TECHNICAL INSTRUCTION

T.I. No: 109/T51

Title: : INSPECTION OF DART 15/17M ALUMINIUM ALLOY (DURAL) SPAR BOOMS

THIS ISSUE 3 SUPERSEDES ISSUE 2 - CHANGES AS BELOW:

FIGURE 1

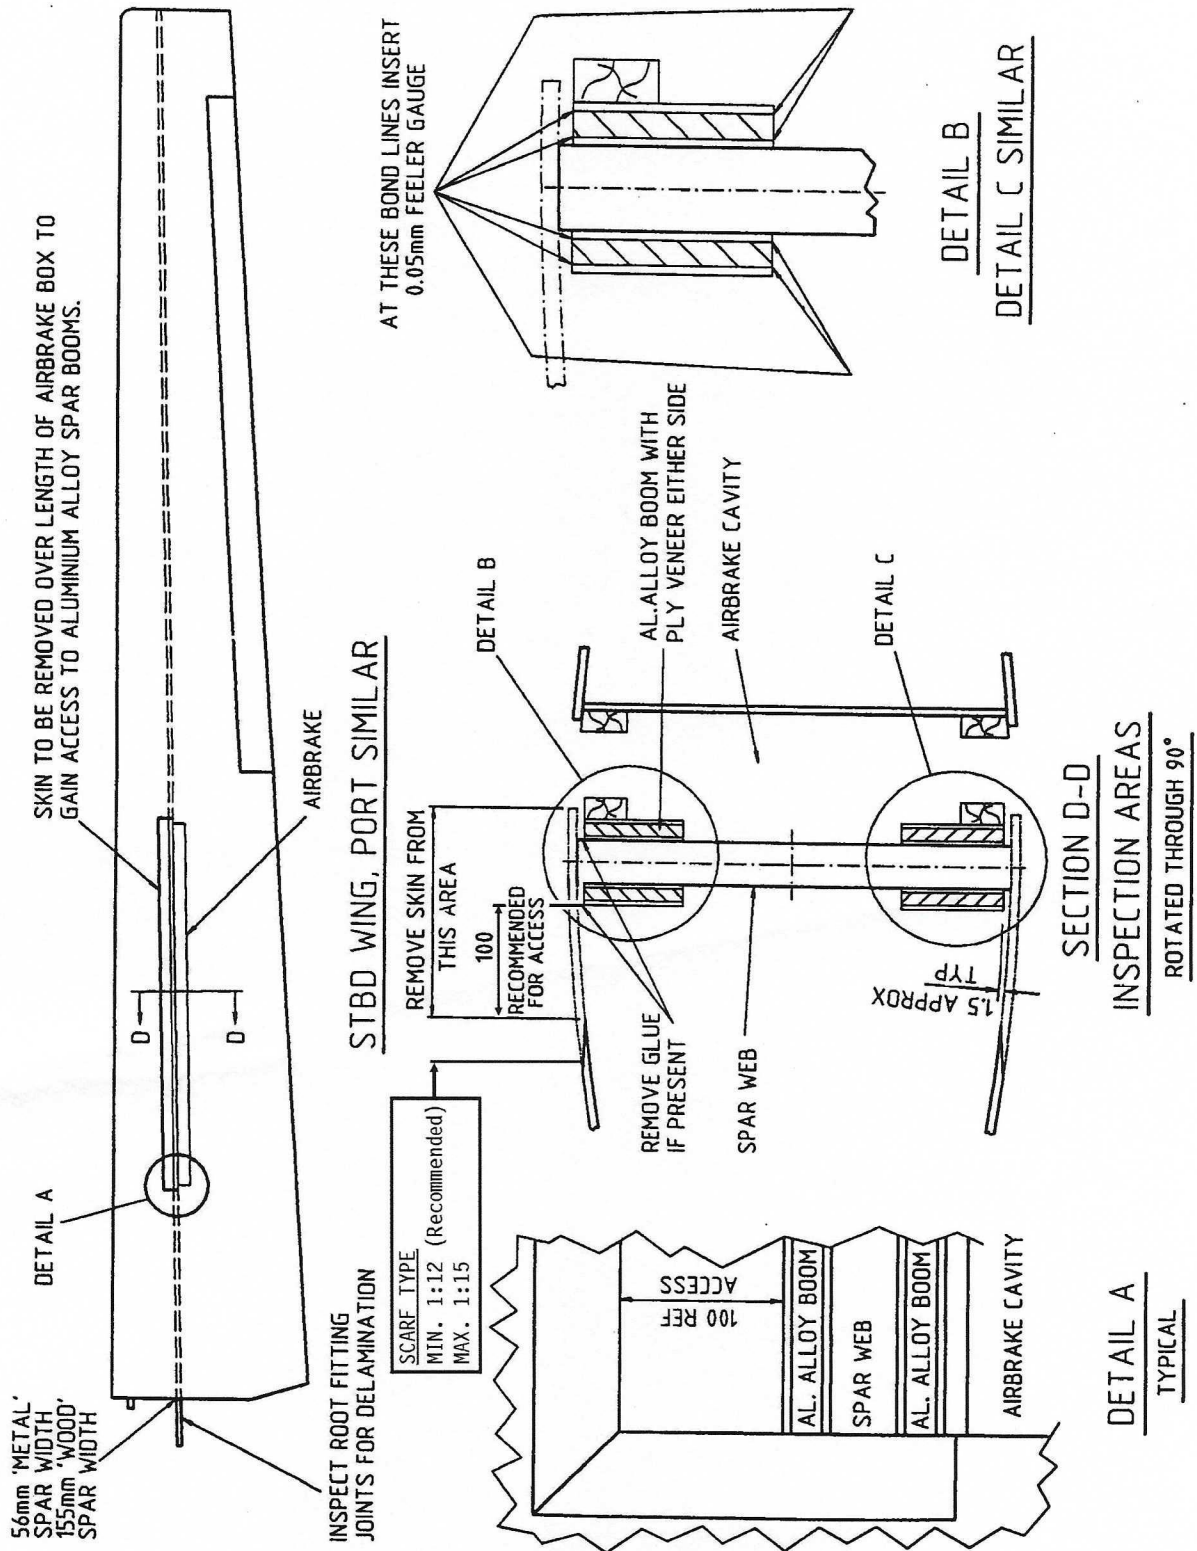
1.
 - i) Carefully remove the ply skin from both wings, over the upper and lower spar for the length of the airbrake box. Refer to Fig. 1.
 - ii) Carefully remove paint to expose root fitting joints.
2. Ensuring aluminium alloy booms are not damaged, carefully clean away any "Redux" that may have spilt from the joints during manufacture.
3. With the aid of a feeler gauge, .002" (.05mm) check for the integrity of all exposed joints for delamination and/or exfoliation corrosion (white powdering on the metal). Ref Fig. 1 Detail B and C.
4.
 - i) If delamination or corrosion is found, the damage must be repaired before further flight. Inform SAL of the extent of the damage before proceeding with boom repairs.

FIGURE 2

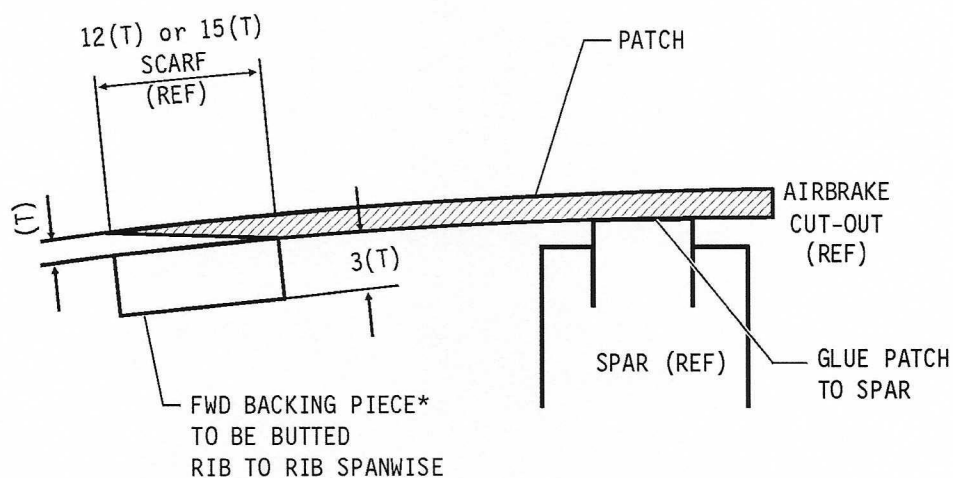
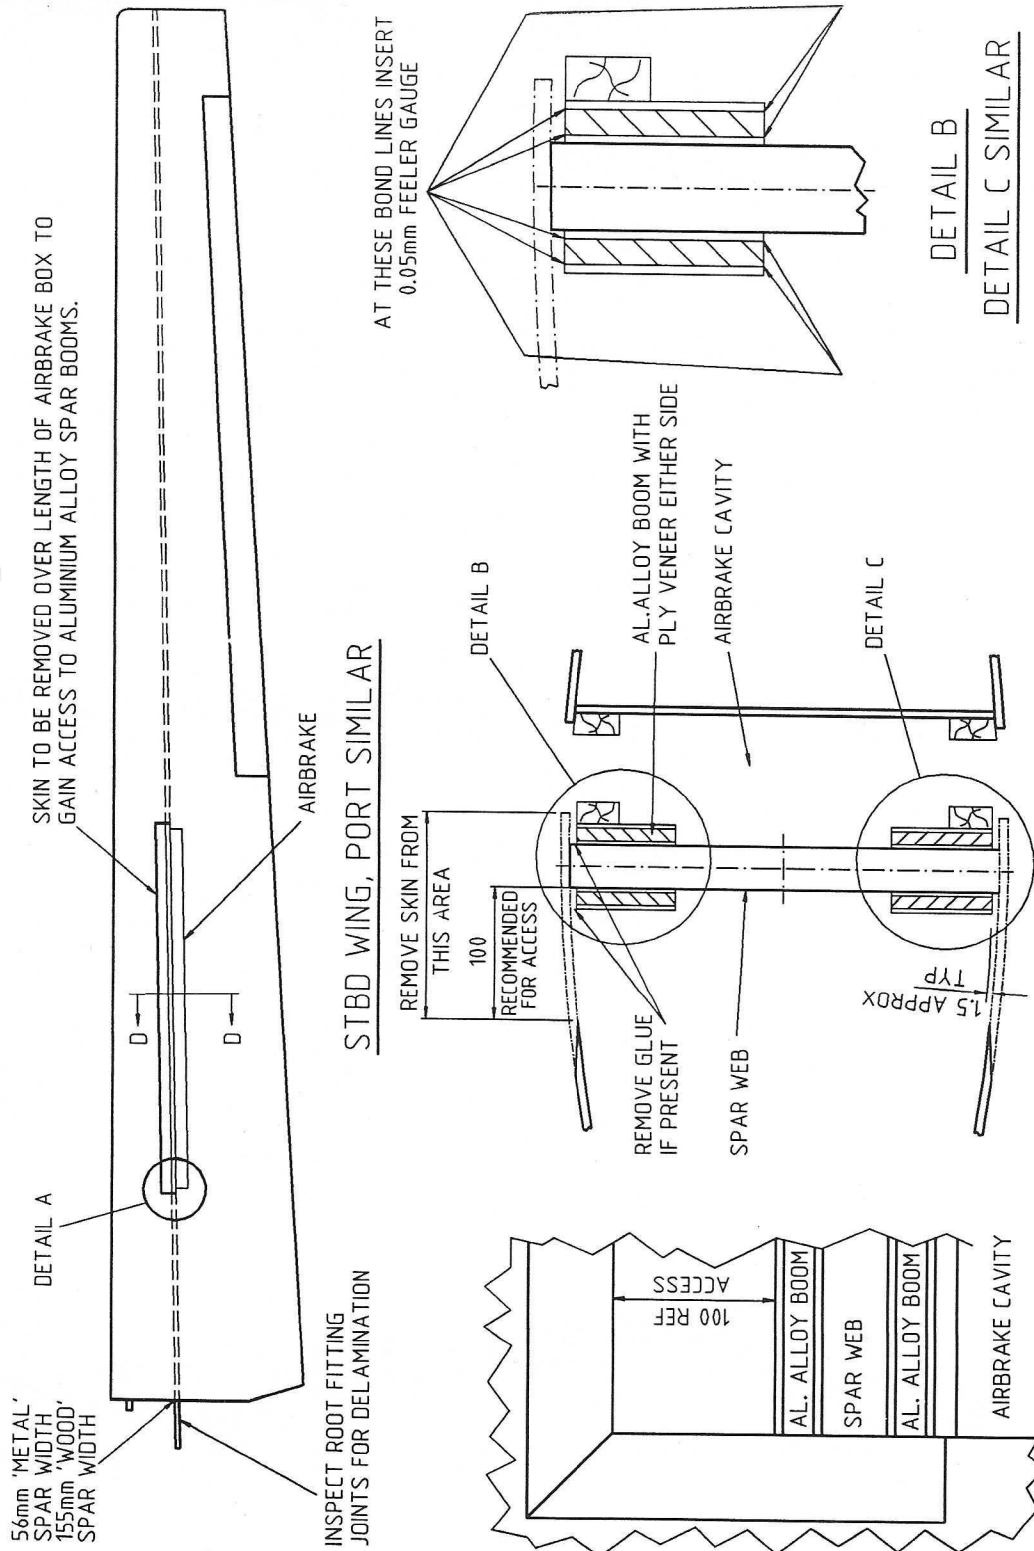
Repair as per page 5 of this TI. Also refer to FAA EA-AC43.13-1A & 2A Acceptable Methods, Techniques and Practices Aircraft Inspection and Repair Para 23.

*FORE AND AFT BACKING PIECE
TO BE BUTTED BETWEEN
FWD BACKING PIECE TO SPAR
